Rocky Mountain Arsenal

North Boundary System Component
Response Action Assessment

Final Technical Plan
(Version 3.1)
February 1988
Contract Number DAAK11-84-D-0016
Task Number 36

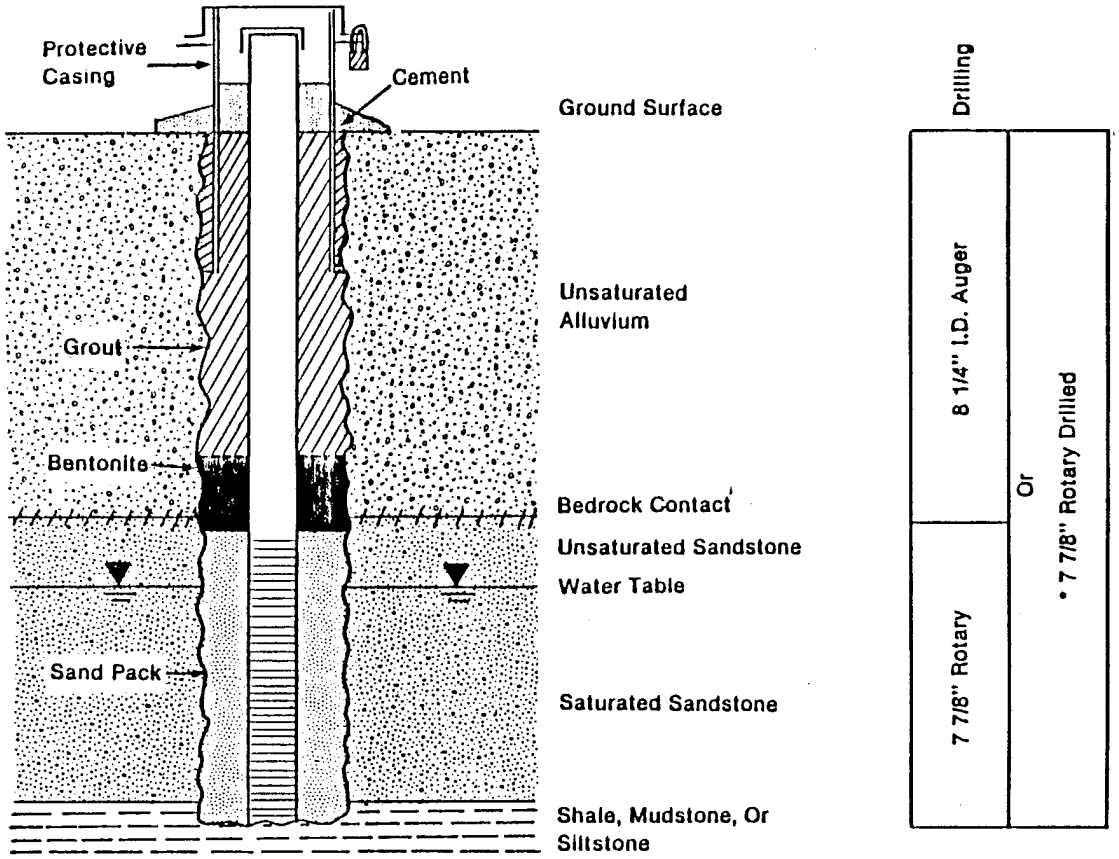
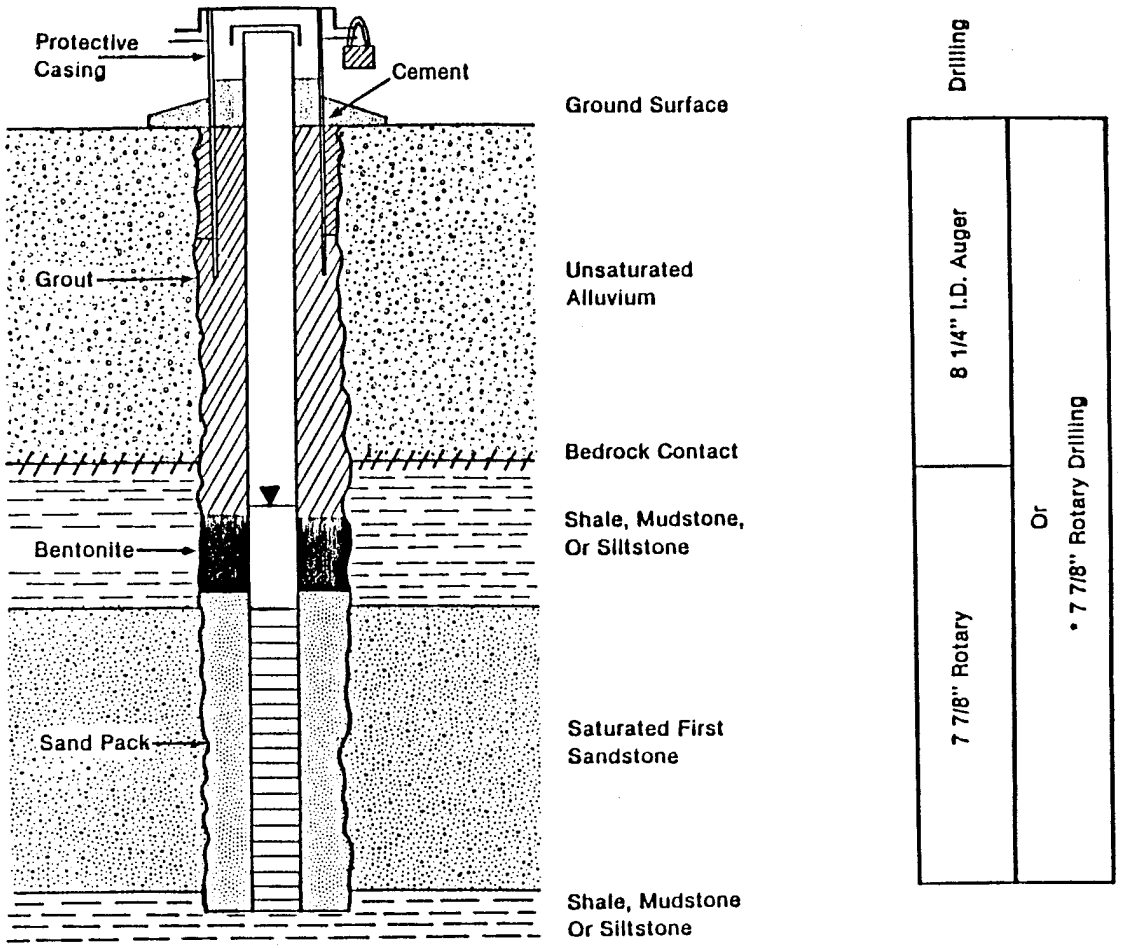
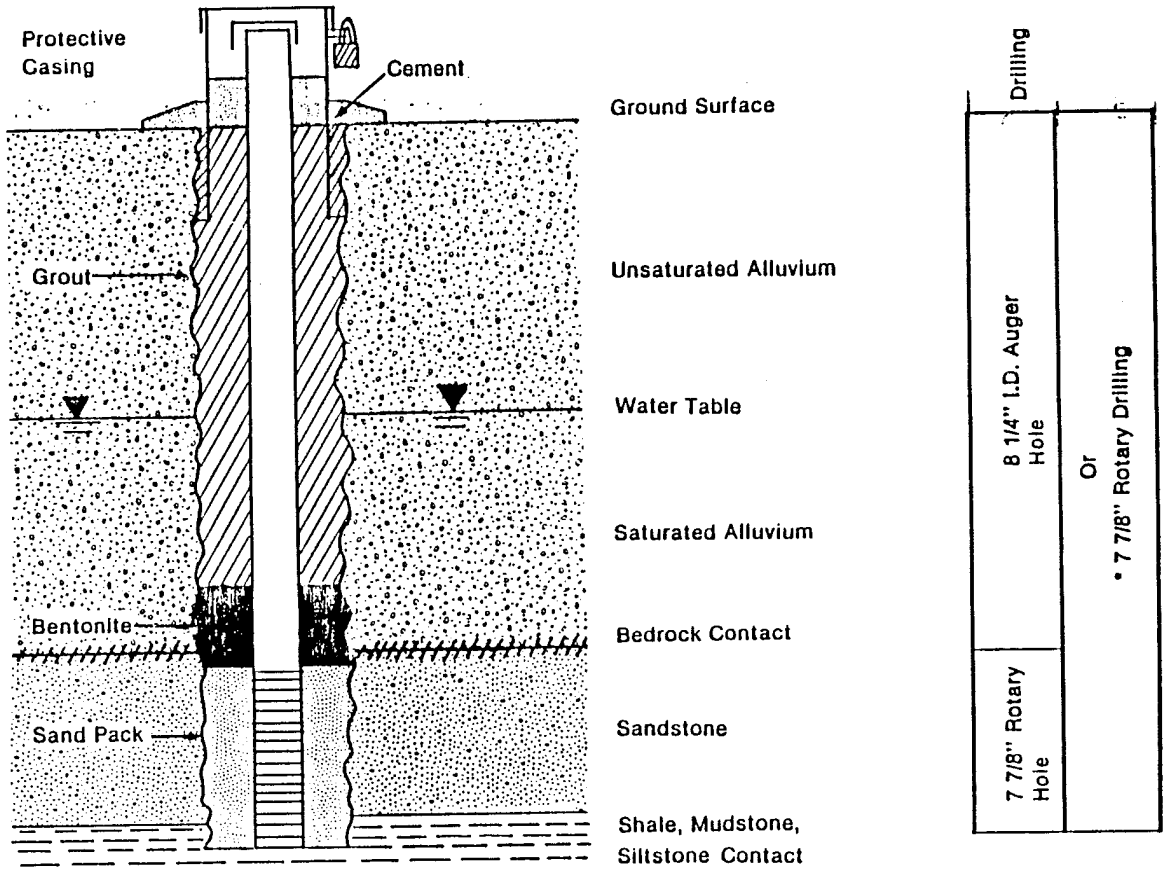
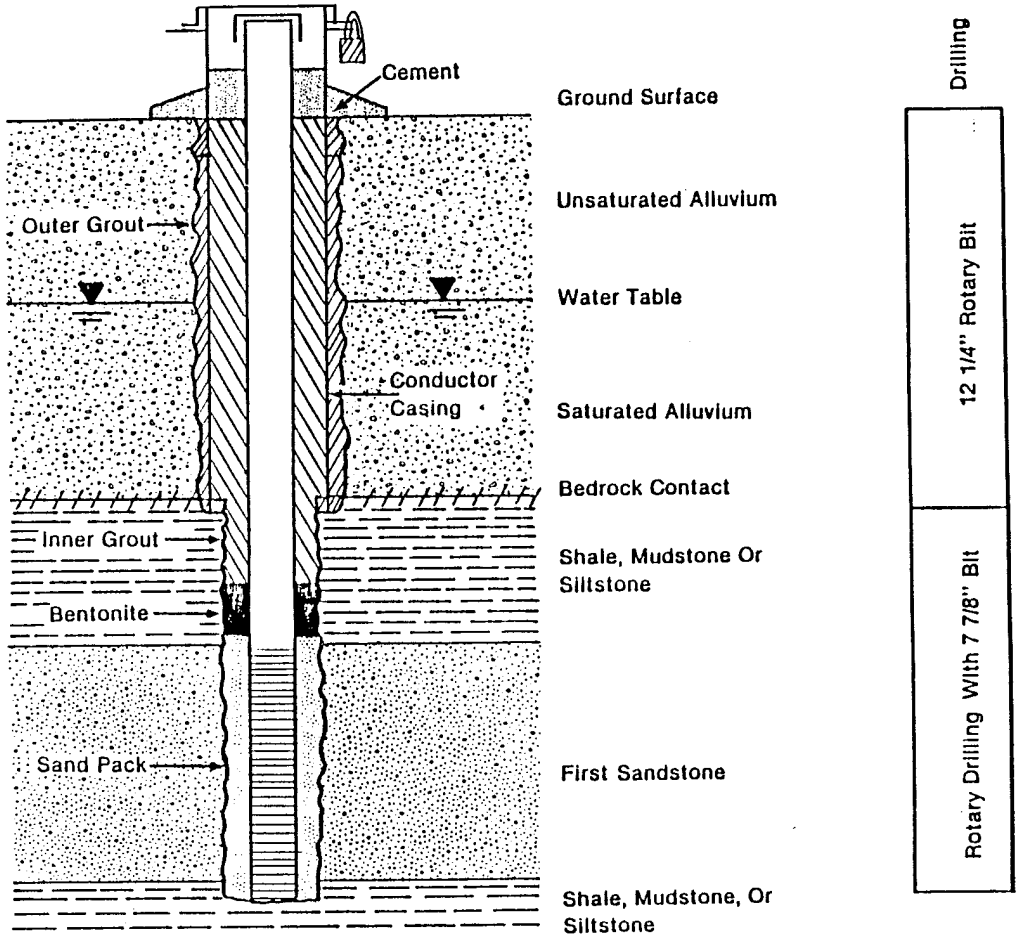
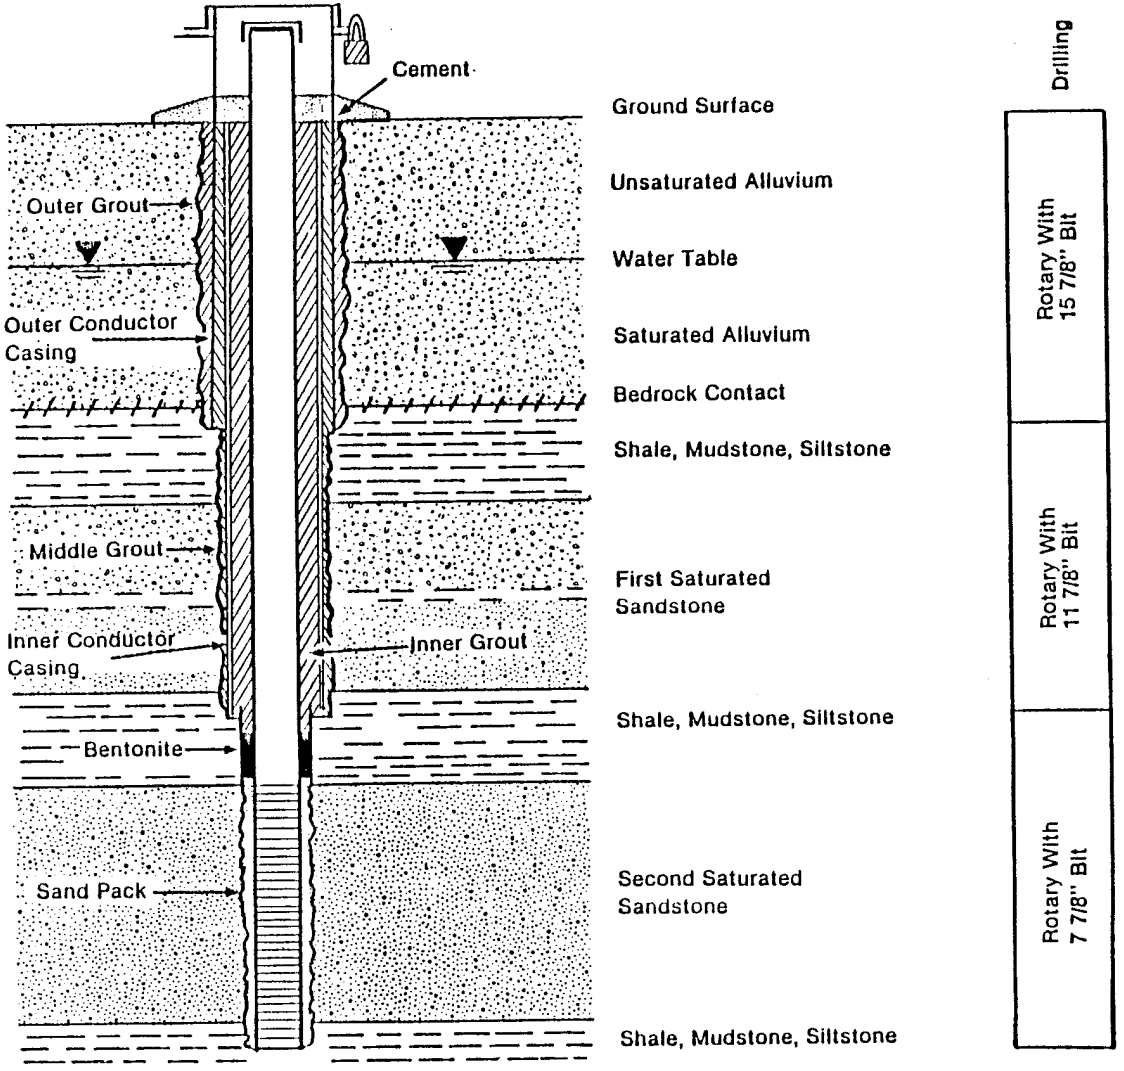
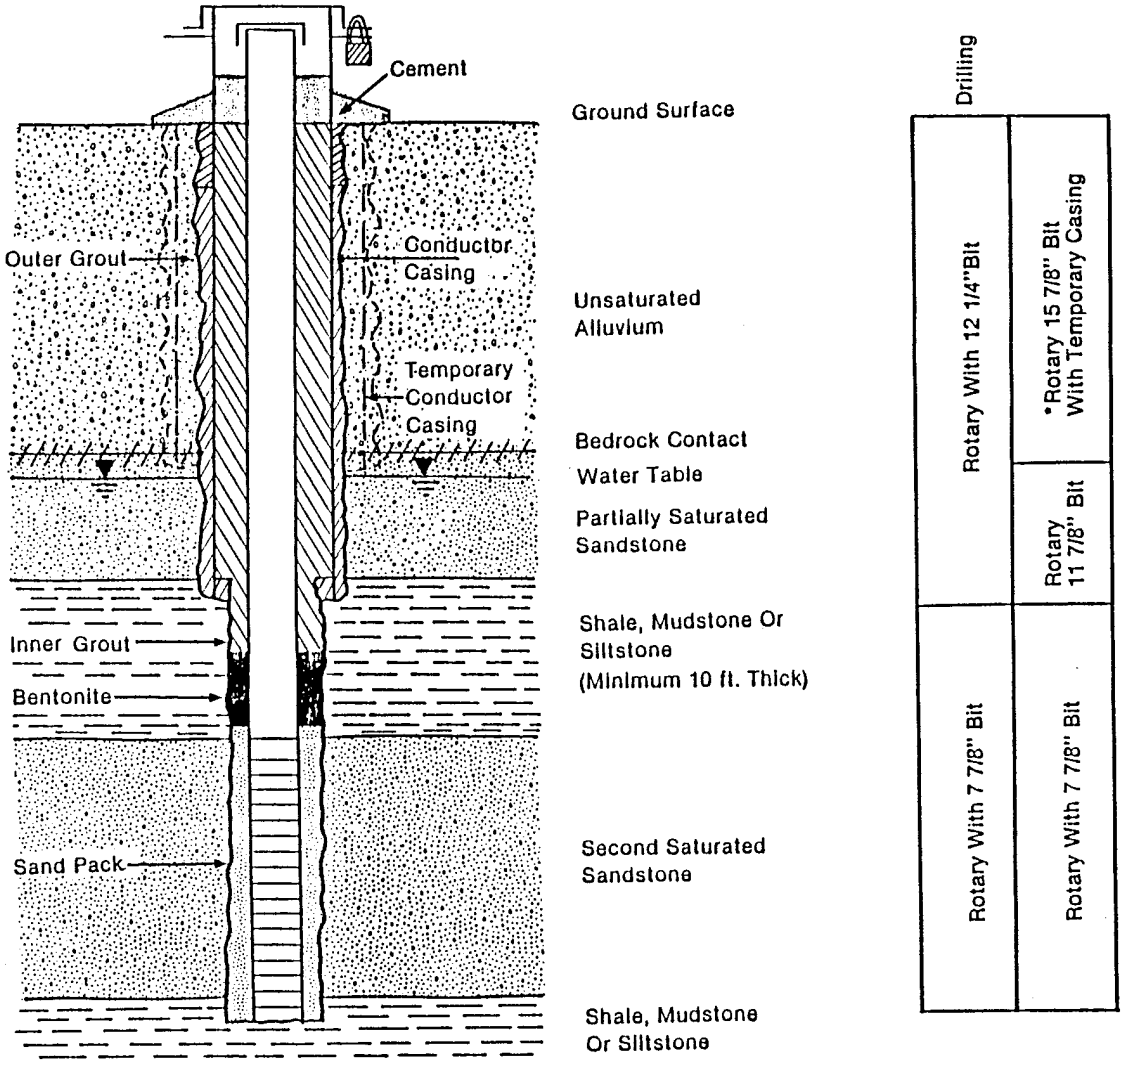
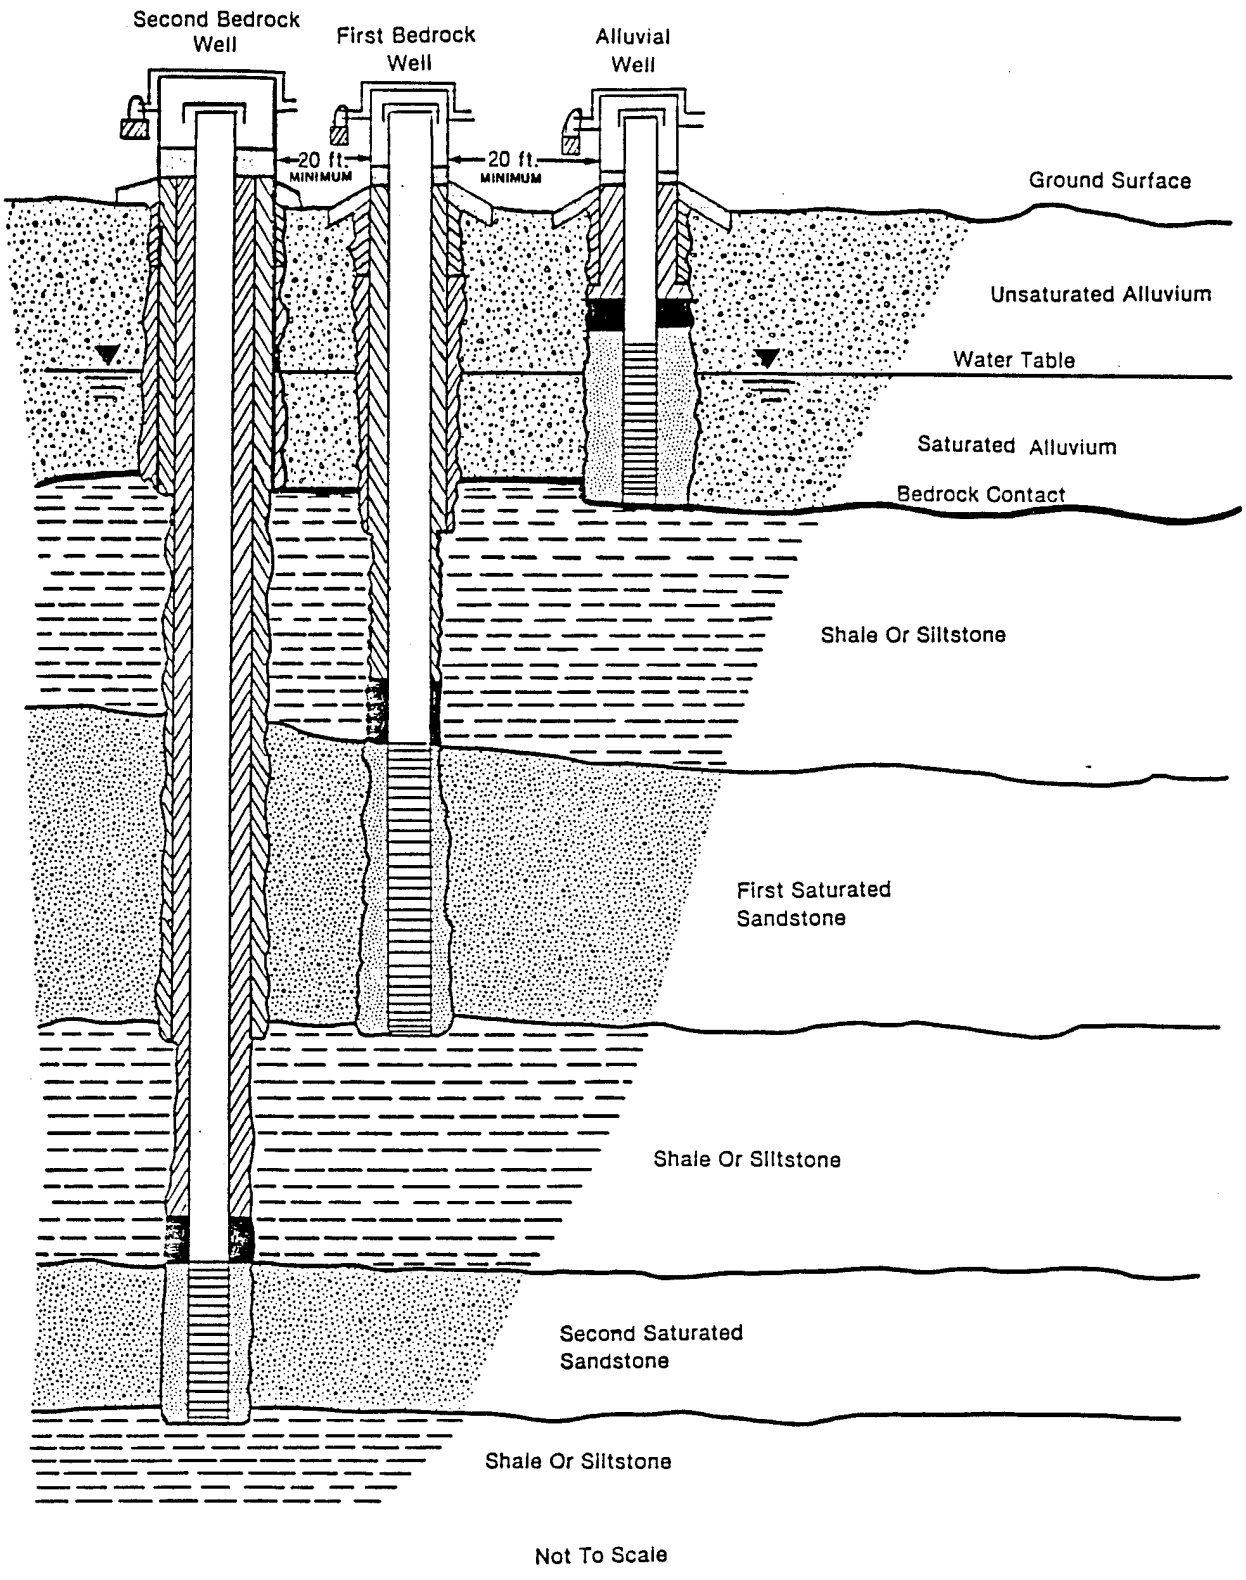
Figures 3.2-2a through 3.2-3. Construction details and contingencies for installing monitoring wells in shales/claystones of the Denver aquifer that show evidence of fracturing must be included in the technical plan.
